Introduction:

The 886LCD-M boards with Part-numbers :

Board Design Update:

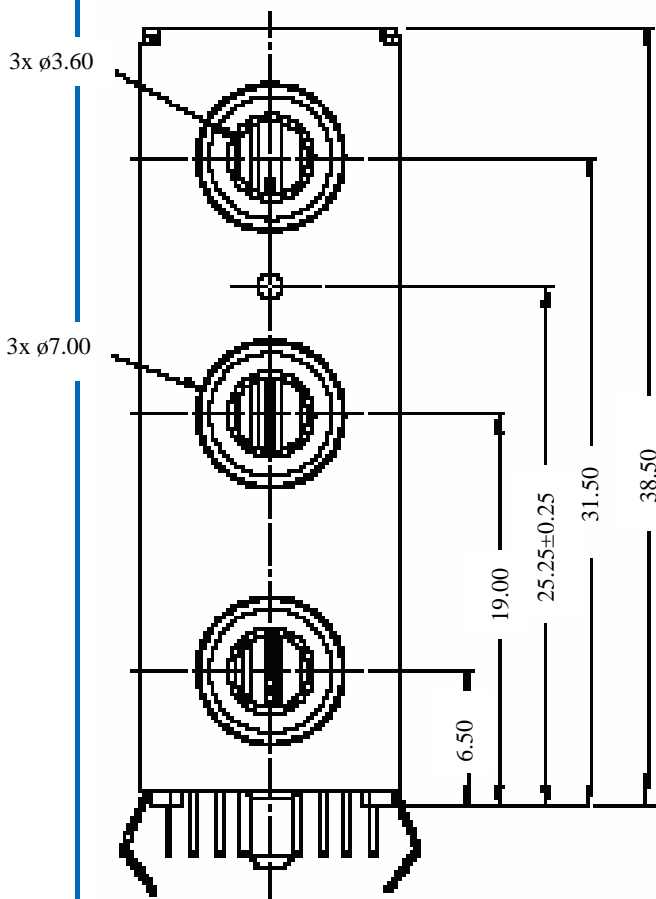
1. RoHS compliant components and Printed Circuit Board (PCB) used for the manufacturing of the RoHS compliant boards. RoHS compliant production process has been implemented.
2. Hardware Watchdog functionality extended to provide longer Time-out values.
3. ETHER1 and ETHER2 Enable/ Disable control improved. The change is transparent to the user.
4. "PCB ID" and "Part #" numbers updated in BIOS menu / onboard Eeprom.
5. Audio connector stack changed to be 1U compliant connector. Please refer to mechanical drawings next page for change.

No mechanical changes to Connectors, **except** for Audio connector stack. Please refer to below change information. **NOTE: please review Bracket Design.**

Previous Audio Stack

Updated Audio Stack
